NUMBER
231 (Rev 3, 11/30/2021)

TECHNICAL SERVICE BULLETIN

**FRONT VIEW CAMERA REPLACEMENT
FOR DTC C160449 & C160649**

Front View Camera

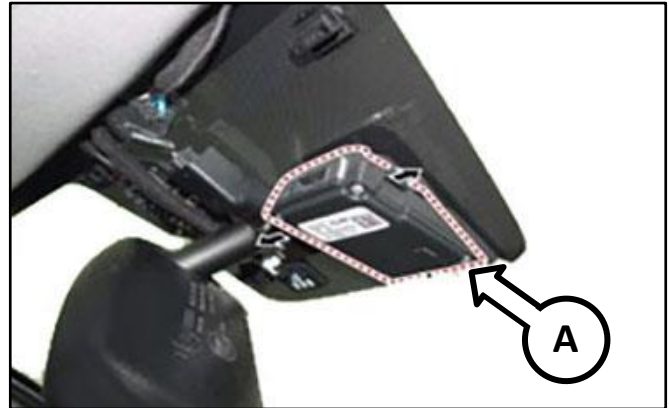
This bulletin provides information on the inspection and replacement of the front camera on some vehicles listed below. Due to an internal control chip concern inside the camera, the vehicle may exhibit a Forward Collision Avoidance Assist Warning Lamp (A) and/or Master Warning Lamp (B) with C160449 and/or C160649 codes. Certain systems may become temporarily disabled during occurrences: Smart Cruise Control (SCC), Lane Keep Assistance (LKA), Lane Departure Warning (LDW), Forward Collision-Avoidance Assist (FCA), Forward Collision Warning (FCW) and/or Driver Attention Warning (DAW). Follow the procedure outlined in this publication to diagnose and replace the front view camera assembly.

1. Remove and replace the Front View Camera (A) by referring to the “Body Electrical System → Front Camera System → Front View Camera Unit → Repair Procedures” chapter in the applicable Shop Manual on KGIS.

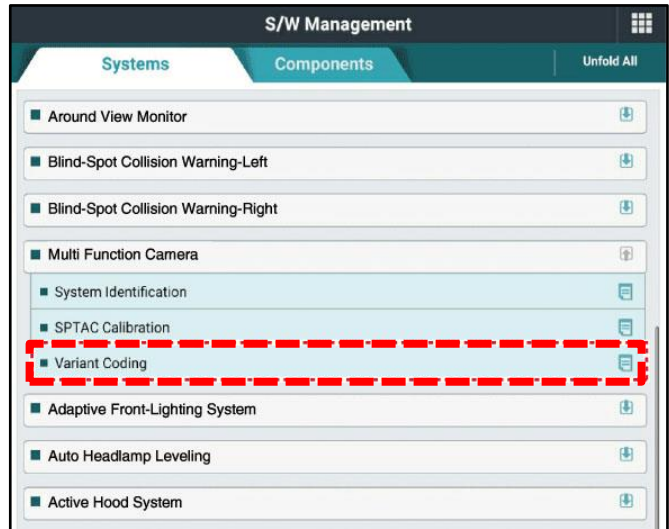
2. Perform the “Variant Coding” procedure by referring to the “Body Electrical System → Front Camera System → Repair Procedures” chapter in the applicable Shop Manual on KGIS.

ⓘ IMPORTANT
 After replacing the front camera with a new unit, the **Variant Coding** procedure **must** be performed.
